## **Addendum No. 1**

**RFP 08-10350-3618**

### **Roadway and Campus Fiber Installation Services for Uniontown to Brownsville Phase I**

DRAWING TO CLARIFY MAINLINE INTERCHANGE M-19 TO REDSTONE TOWER - CONDUIT AND JB LAYOUT.

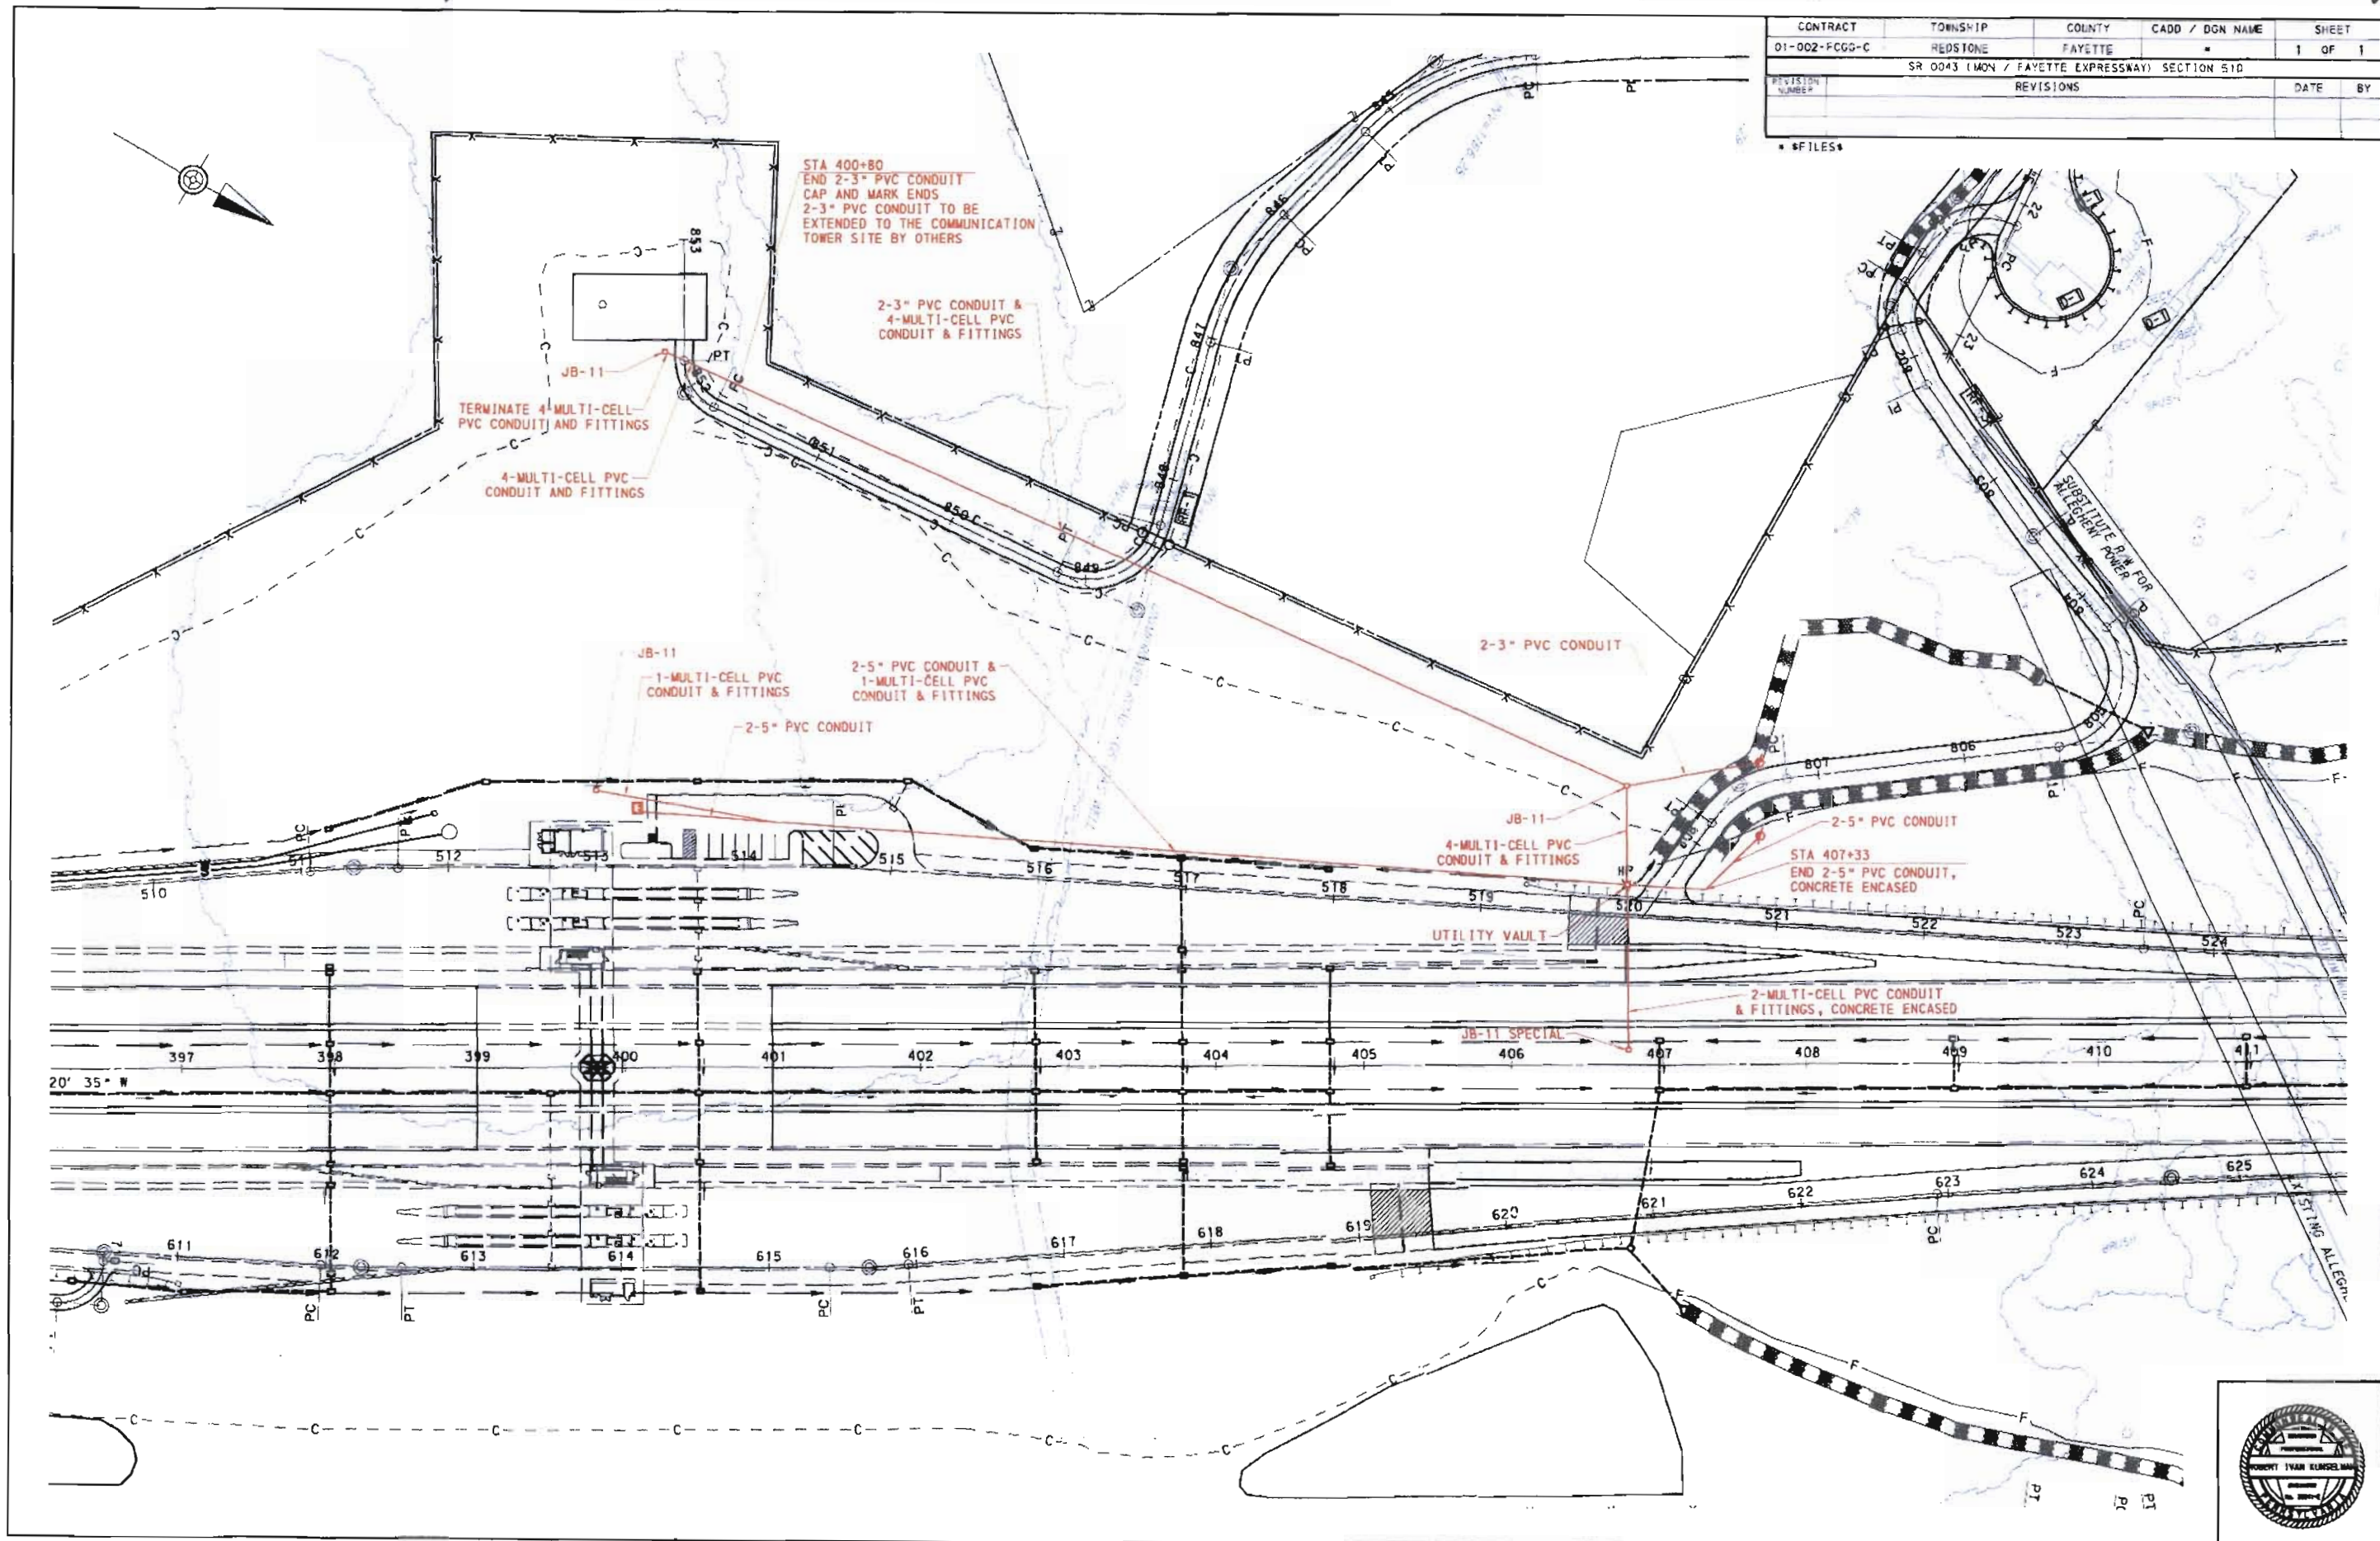
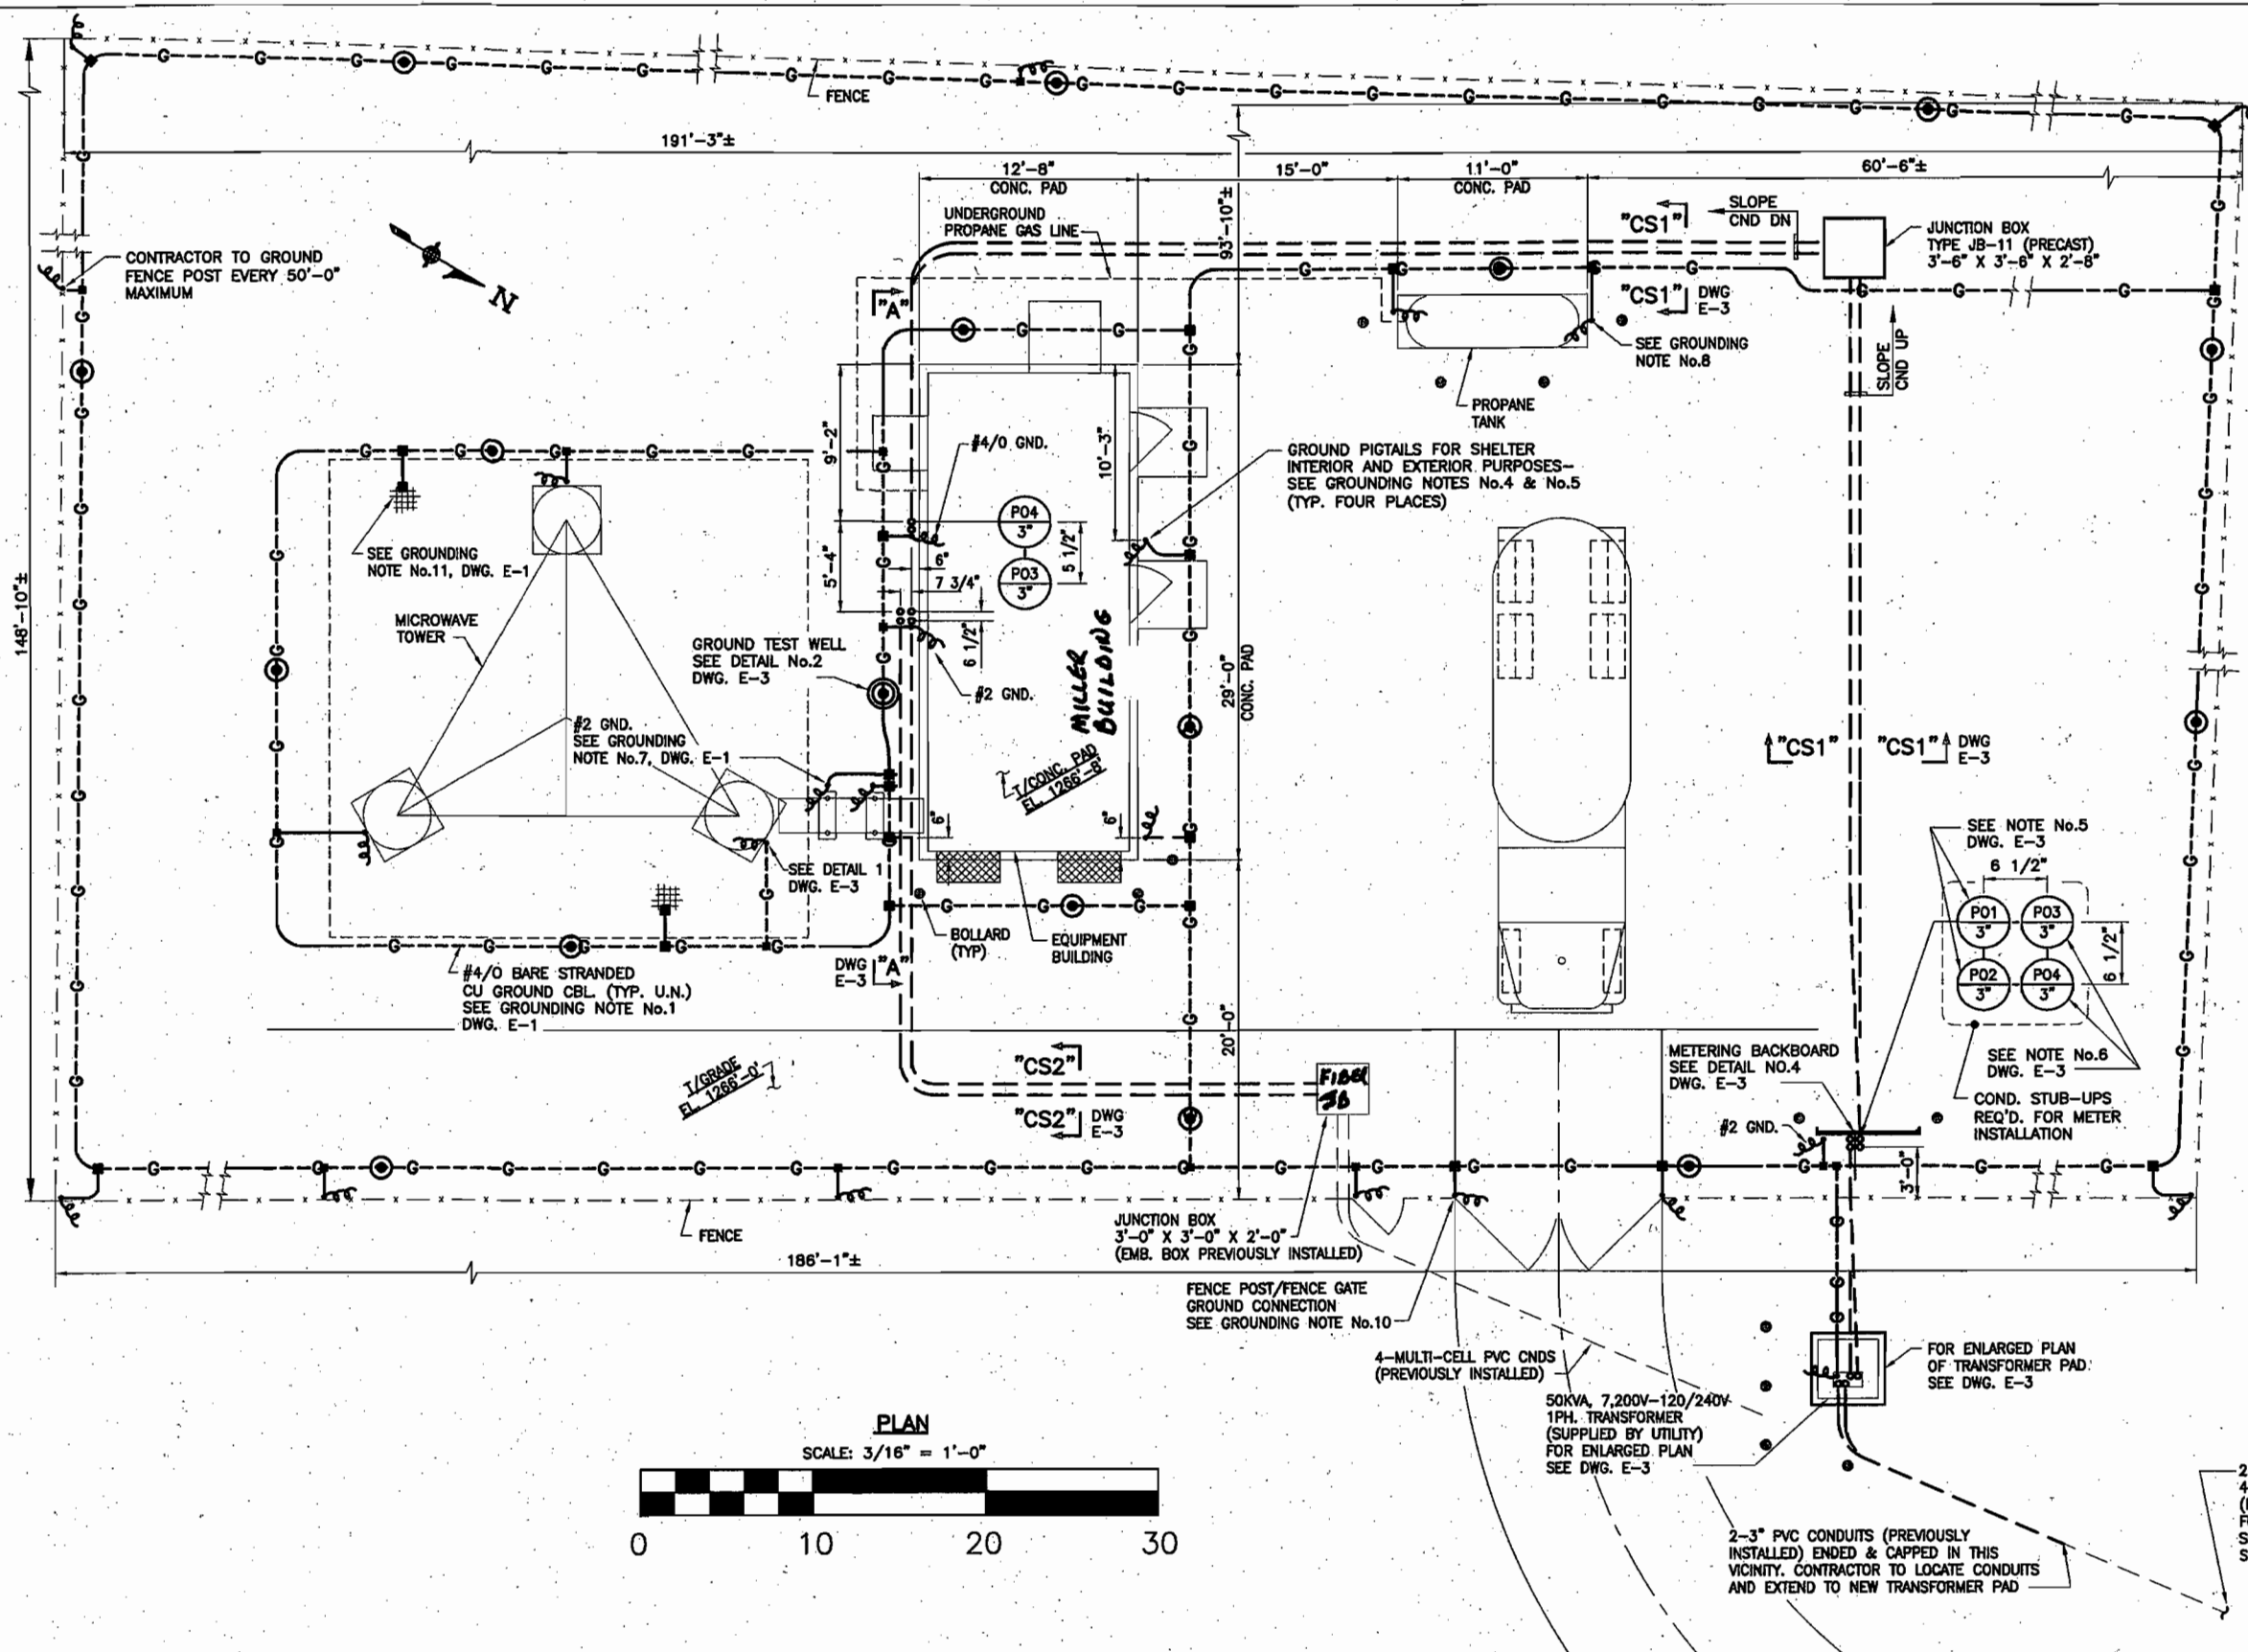
**This drawing will provide a better view of the multi-duct conduit layout up to the Redstone Tower site, specifically at the location where it crosses from the mainline median area and goes up the hill to the tower.**

**The duct crosses from a JB-11 in the median at approx station 407+20 and goes to a JB-11 up on the hillside near the right-of-way fence. Between these two JB-11's is a utility vault that the conduits go through. The vault is accessible through a manhole lid and is located at the bottom of the hill in the swale area just off of the shoulder. We saw this manhole during the site visit, but it was not obvious that it was part of the raceway system. The conduits run over to the mainline toll facility from this vault and not from the JB-11 by the fence.**
